Appl. No. 10/688,185  
Amdt. Dated November 26, 2007  
Reply to Office Action of September 12, 2007

### **REMARKS/ARGUMENTS**

#### **Drawings**

FIG. 1

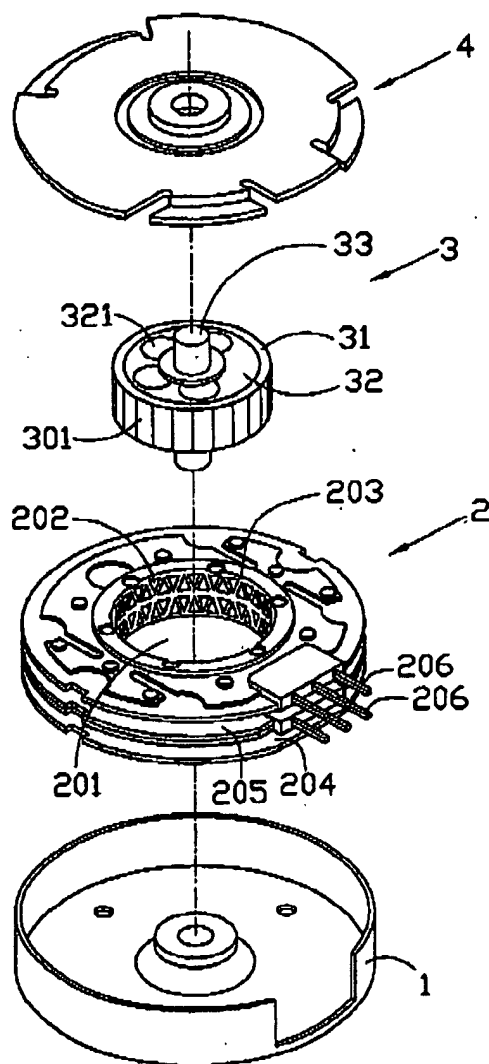
The drawings are objected to by the Draftsperson under 37 CFR 1.84(l) and 37 CFR 1.84(p). Furthermore, the numerical label (4) for the upper housing is missing from Fig. 1.

In response to the drawing objections, applicant has amended Figs. 1-2 and submits Replacement Sheet to replace the originally filed drawings. Every lines, numbers and legends in the drawings of the Replacement Sheet have good quality and are well defined, plain and legible. Furthermore, the reference character "4" has been added to Fig. 1 to show the upper housing. Accordingly, the drawing objections are overcome.
